# UNITED STATES PATENT AND TRADEMARK OFFICE

| APPLICATION NO. | FILING DATE | FIRST NAMED INVENTOR | ATTORNEY DOCKET NO. | CONFIRMATION NO. |
|-----------------|-------------|----------------------|---------------------|------------------|
| 10/732,942      | 12/11/2003  | Rita L. Faunce       | 211552-00050        | 7274             |

| <b>Office Action Summary</b> | Application No.<br>10/732,942 | Applicant(s)<br>FAUNCE ET AL. |  |

**DETAILED ACTION**

FIG. 2

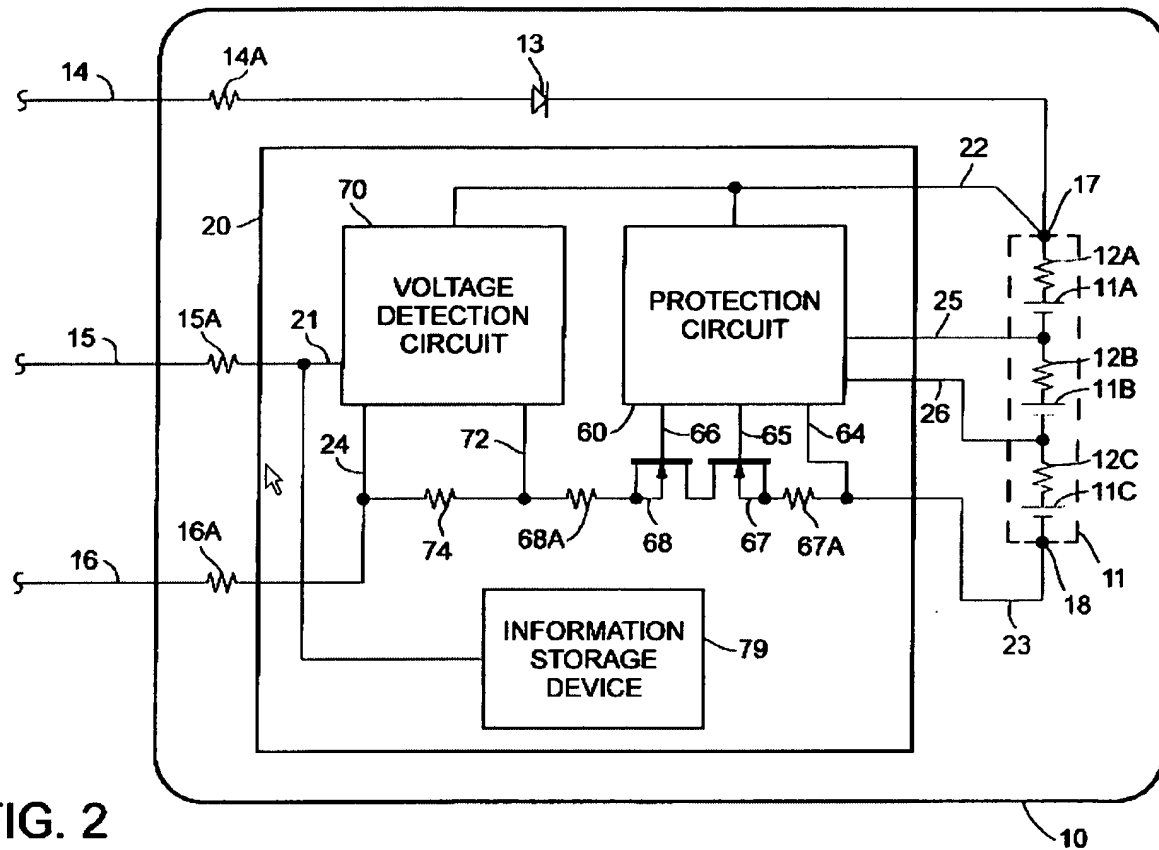
Ostergaard discloses in figures 1-13 controlling charging of a lithium ion battery based upon a measurement of charging current by measuring a voltage drop across a resistor R74 [see column 7, lines 43-45].

(19) Circuit 70 monitors the charging/discharging current by measuring the voltage drop across sense resistor 74 via lines 72 and 24. The protection

Ostergaard does not disclose an indicator responsive to said first charge indication signal for providing an indication when said lithium ion battery is at near full state-of-charge.

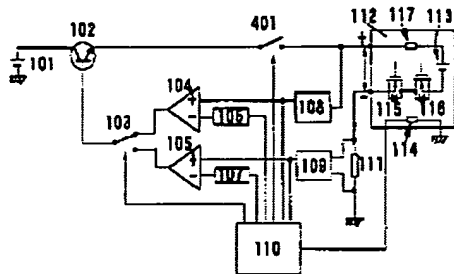
**JP-2002142380** discloses

a power supply 101 and an output drive circuit 102 supply a lithium-ion battery 113 to be charged with direct-current power with the output thereof being adjusted. A constant-current adjustment circuit that adjusts the direct-current power to a specified constant current is connected between the positive terminal side of the lithium-ion battery pack 112 and the output drive circuit 102, and a constant-voltage adjustment circuit that adjusts the direct-current power to a prescribed constant voltage is connected between the negative terminal side of the lithium-ion battery pack 112 and the output drive circuit 102. A control switch circuit 103 switches between these connections. A charging switch 401 is turned off when the electromotive force of the lithium-ion battery 113 is checked during a charging period. A control logic circuit controls switching between constant-voltage control and constant-current control, switching of the charging switch 401, and control values for constant voltage and constant current.

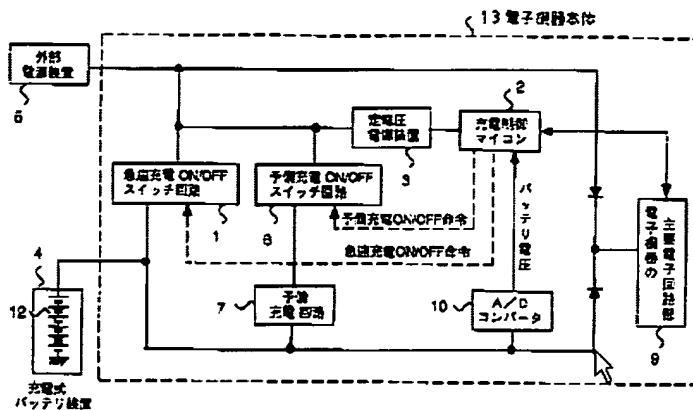
**JP-08140281** discloses

a charging control microcomputer 2 starts the charging, and turns off a quick charging ON/OFF switch circuit 1 so as to perform preliminary charging, and turns on a preliminary charging ON/OFF switch circuit 6. And, a charging control microcomputer 2 reads the output voltage of a charging battery device 4 through an AD converter 10, and if it is not less than the voltage with which the charging control microcomputer 2 can operate, the charging control microcomputer 2 turns off the preliminary charging ON/OFF switch circuit 6 and turns on the quick charging ON/OFF switch circuit 1 so as to perform quick charging until the output voltage of the chargeable battery device 4 becomes stable. Hereby, the chargeable battery device 4 overdischarged can be activated, and it can be quickly charged, with output increased.

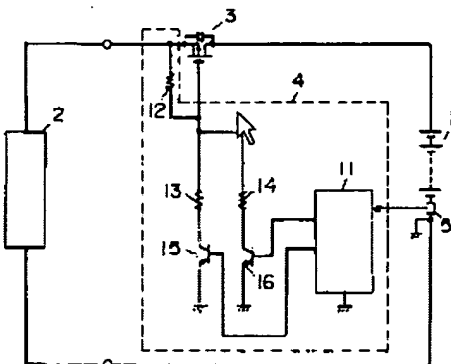
JP-11164489 discloses

a charging controller is provided with a lithium battery 1, a charge power source 2 for charging the secondary battery 1, a charge switching FET 3 formed at a charging passage for charging the secondary battery 1 from the charge power source 2, and a charging control means 4 for controlling the charging switching FET 3. By controlling the voltage between the gate and source of the charging switching FET 3 through a charge control means 4 so that a charging current value becomes a prescribed value, quick charging and trickle current charging for the secondary battery 1 can be conducted with a single charging switching FET 3, and current control limiting resistance can be eliminated. Thus a charging controller built in secondary battery pack can be provided which is able to attain size reduction and trickle current charging at a low cost.
